Memorandum to the City of Markham Committee of Adjustment

December 3rd, 2019

A/81/19

3 Sunflower Crt, Thornhill

SITE STATISTICS

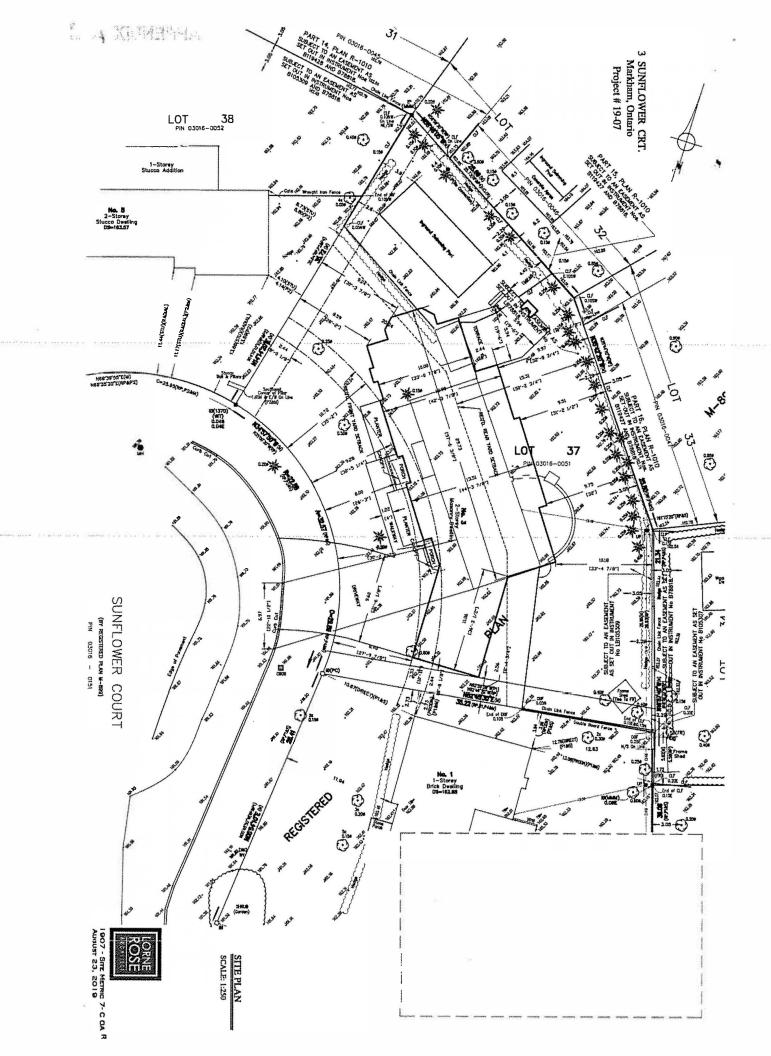
The applicant is requesting relief to permit a minimum front yard setback of 27.75 ft (8.46 m), whereas the By-law requires a minimum front yard setback of 35 ft (10.67 m). This represents a reduction of approximately 7.25 ft (2.21 m) or, approximately 20.7 percent. The variance is attributable to the position of the proposed dwelling relative to the front lot line. While the requested variance applies to a portion of the proposed dwelling, the requested variance will result in a dwelling that is not consistent with the established front yard setback pattern on the street.

REAR ELEVATION 3 SUNFLOWER CRT.
Martham, Ontario
Project # 19-07 109111.30-1C

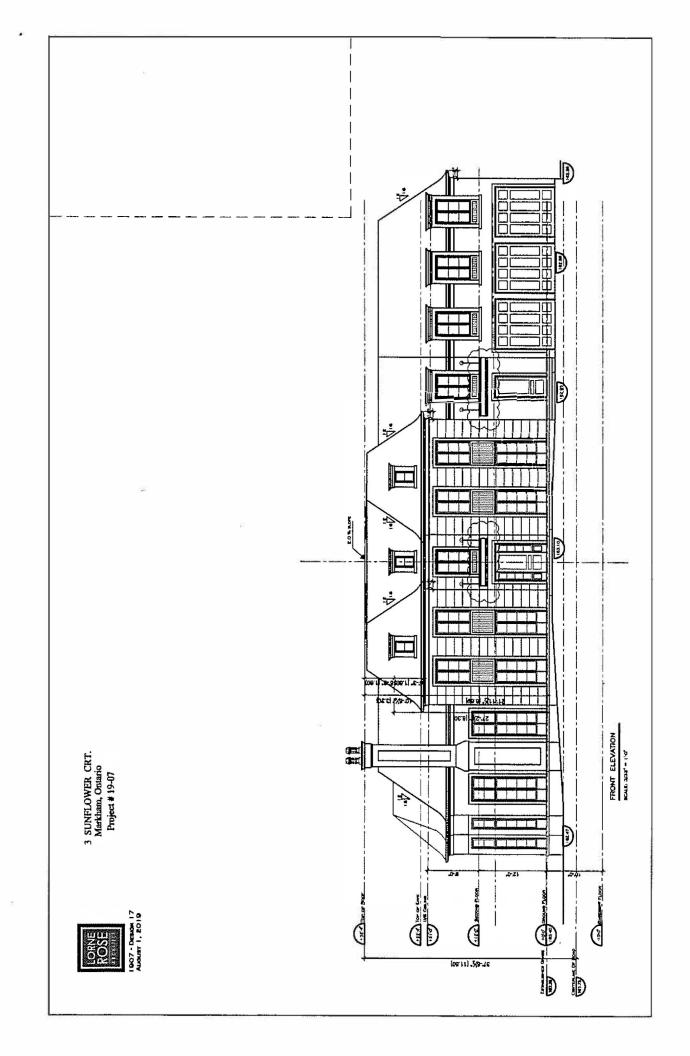
The applicant is also requesting relief to permit a minimum rear yard setback of 31.21 ft (9.51 m), whereas the By-law requires a minimum rear yard setback of 50 ft (15.24 m). This represents a reduction of approximately 18.79 ft (5.73 m) or, approximately 37.58%.

The requested variance applies to the main dwelling and is not generally consistent with the established rear yard setback pattern. The subject dwelling backs onto the rear yards of properties on Laureleaf Road which, require a minimum rear yard setback of 40 ft (12.19 m). Mature vegetation at the rear of the property provides some screening to the properties at the rear.
